DS-K1T671 Series MinMoe Terminal Release Notes (2021-11-15)

Device Model: DS-K1T671M/MF DS-K1T671TMW/TMFW Naming Rule: M for M1 card, W for WIFI, F for fingerprint	Firmware Version	ARM: ACS_671_AI3_EN_STD_V3.2.0_build211110 ACS_671_AI3_EN_NEU_V3.2.0_build211110
	SDK	Latest version
	iVMS-4200 Version	Latest baseline

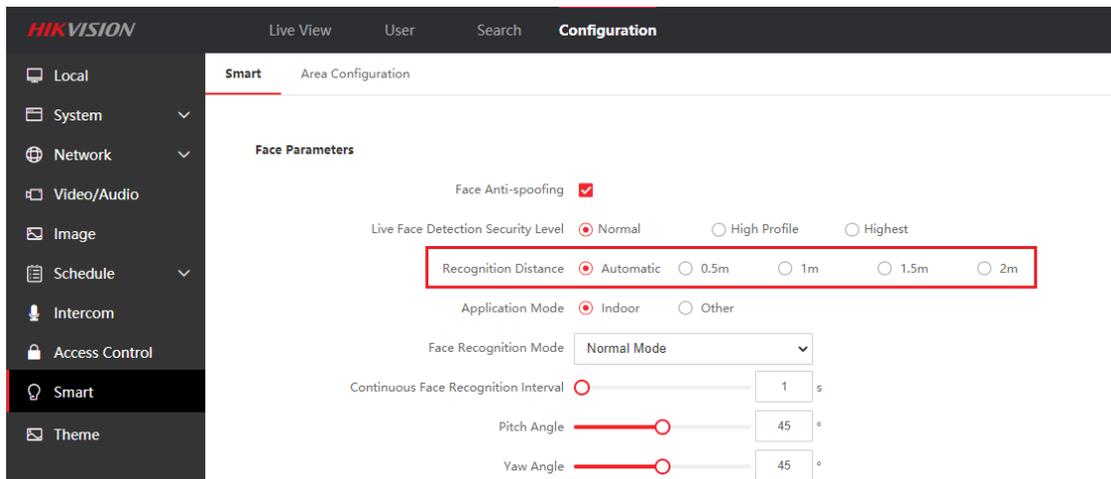
1. Optimize the wake-up distance of the device screen through the face, and the wake-up distance is consistent with the recognition distance

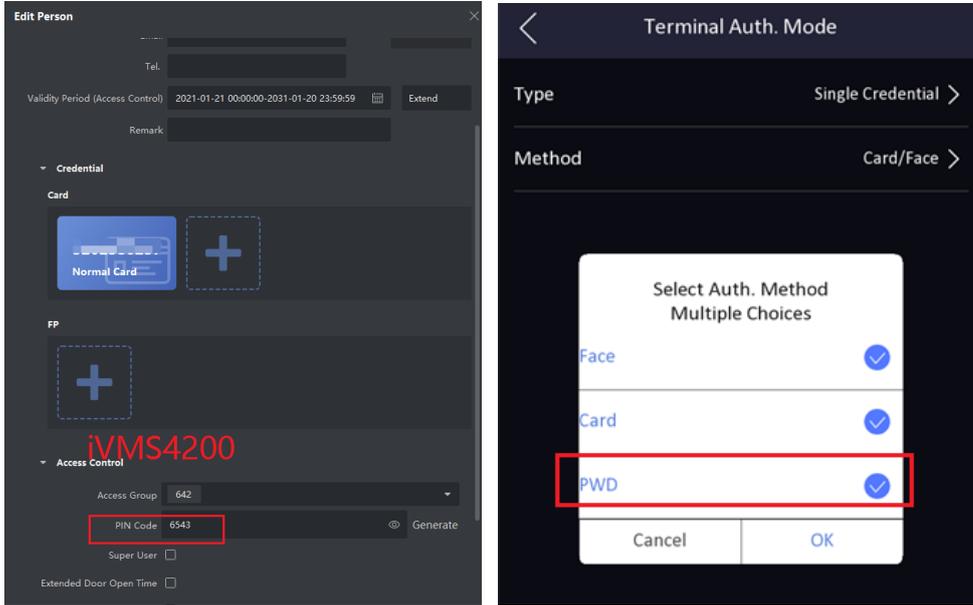
7. Support PIN code to open the door (disabled in default)

Note: PIN code should be configured from software, iVMS4200 already support, HikCentral Pro will support PIN code configuration in V2.1 expected to be released in June

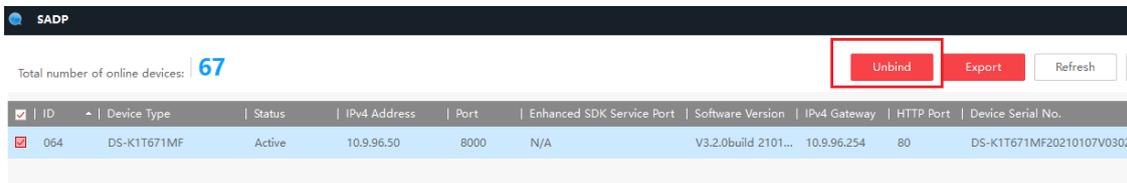
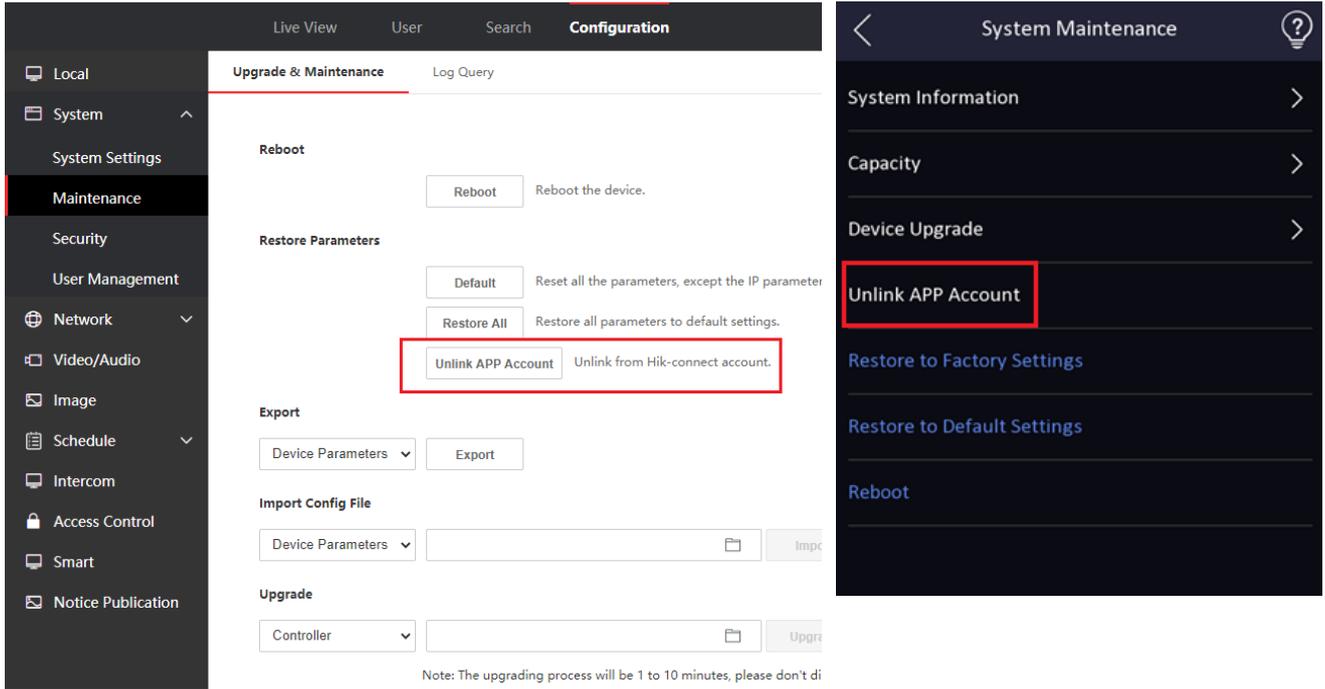
8. Support unbind device with hik-connect account on SADP tool, local UI and web interface

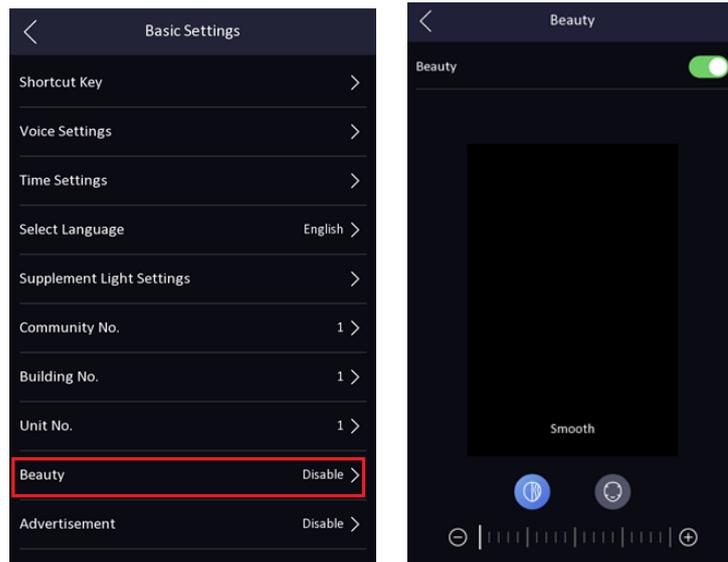
9. Add beauty function to adjust smooth and whiten parameter.

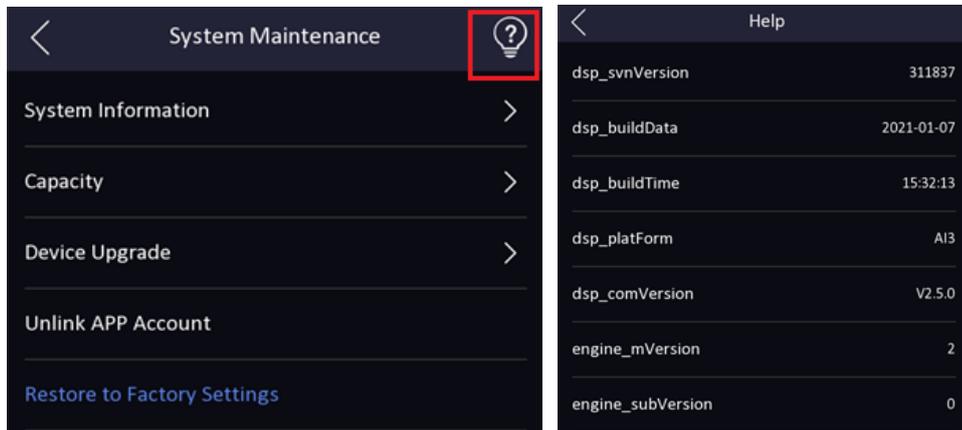
10. Add help interface to check system module version for technical support (long press for 3s).

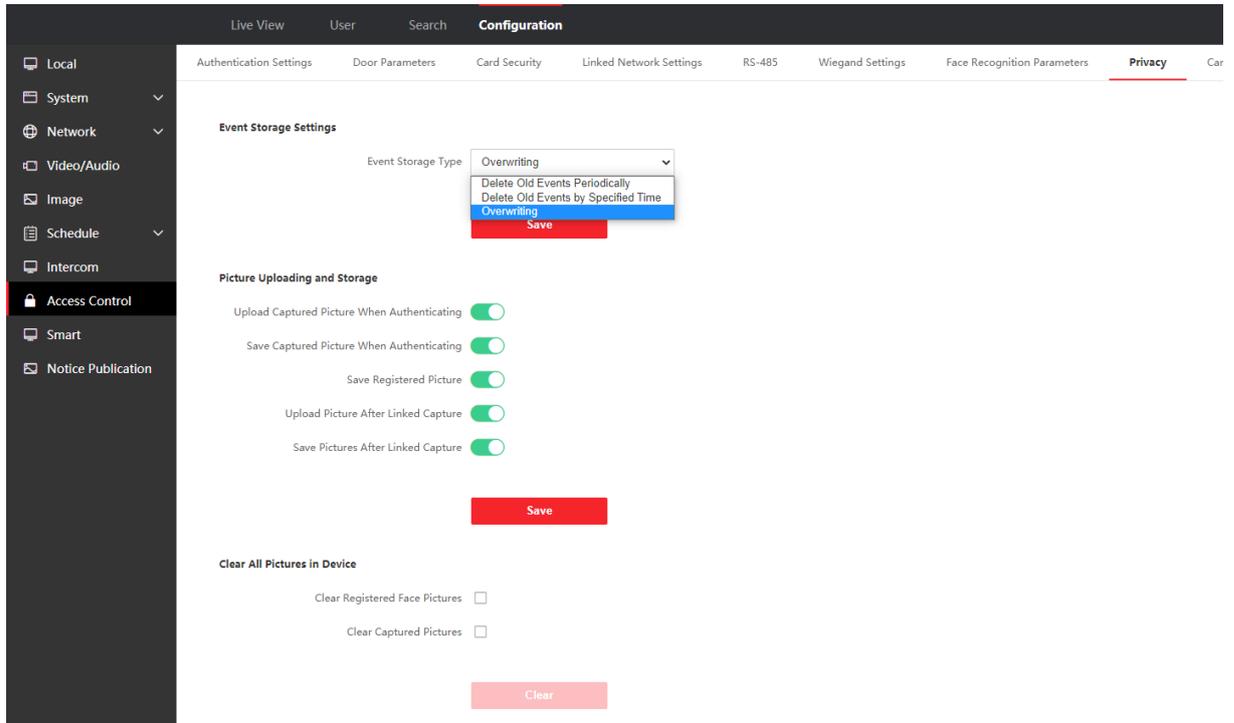
11. Add privacy protection, customer can define the privacy related parameter, such as Event Storage Settings, Picture Uploading and Storage, Clear All Pictures in Device

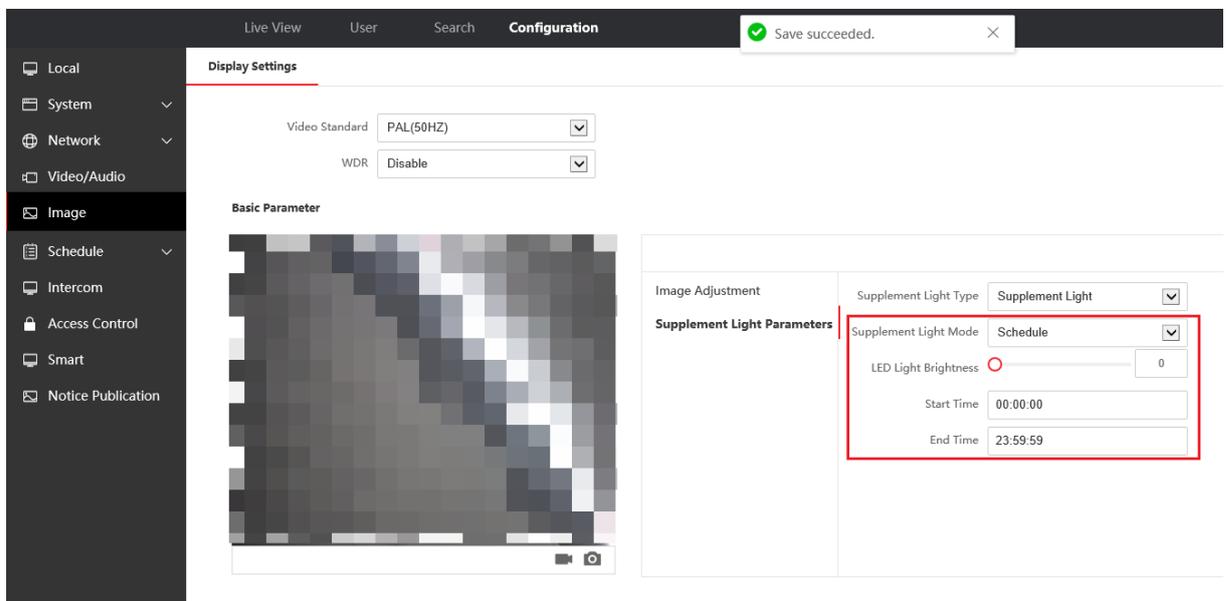
12. Configure the time period when the white light fill light is turned on and off in device local menu or web interface

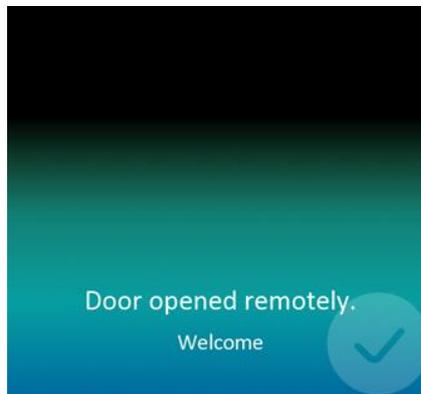
13. Add audio prompt 'The door is open' when open door on iVMS4200, HikCentral Pro, Hik-Connect App, and device UI will show prompt

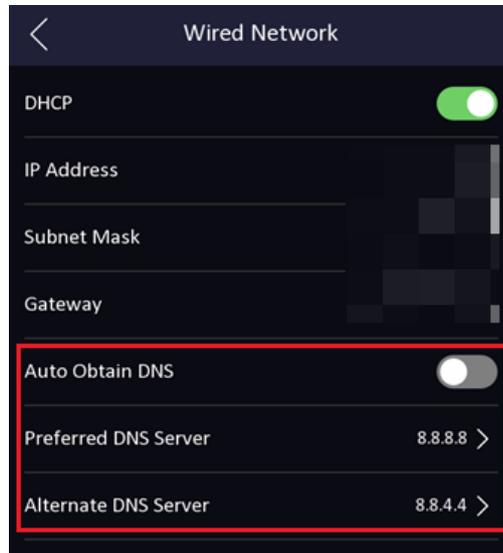
- 5. The face matching algorithm is upgraded. Improve the speed and accuracy of face recognition. Improved the recognition effect of dark masks
- 6. DNS can be configured from device UI in menu → Comm. → Wired Network

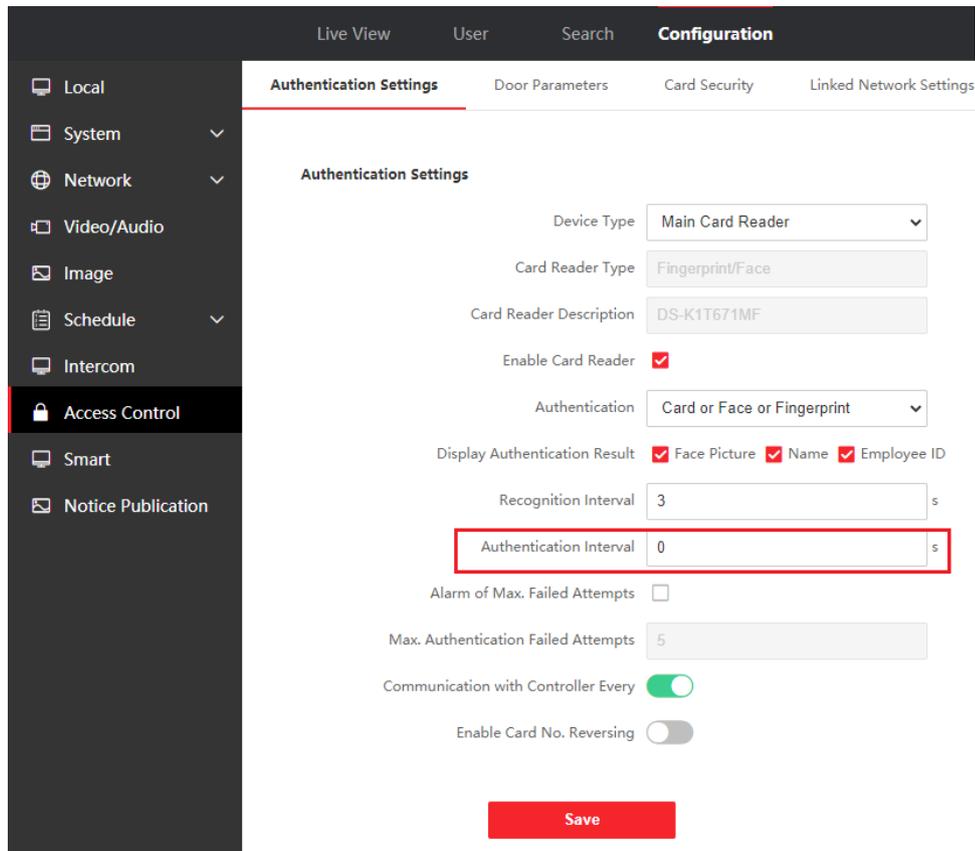
- 7. Optimized the ISUP and Hik-Connect event upload mechanism.
- 8. Add stranger authentication timeout time configuration

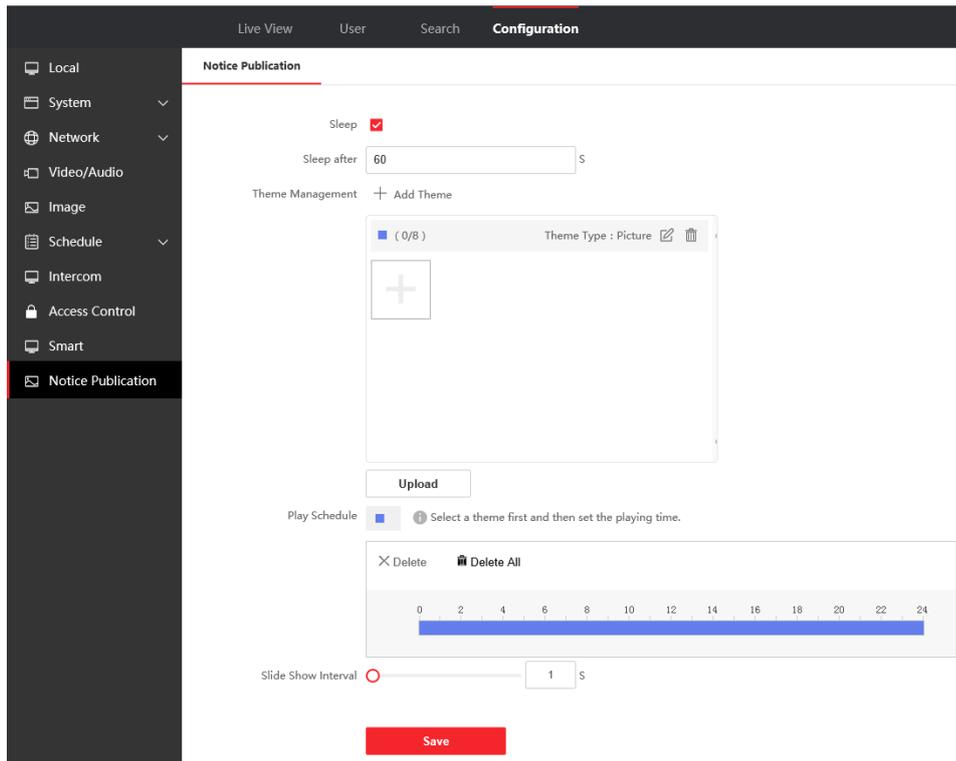
- 9. Add advertisement/wallpaper play schedule configuration, slide show interval.
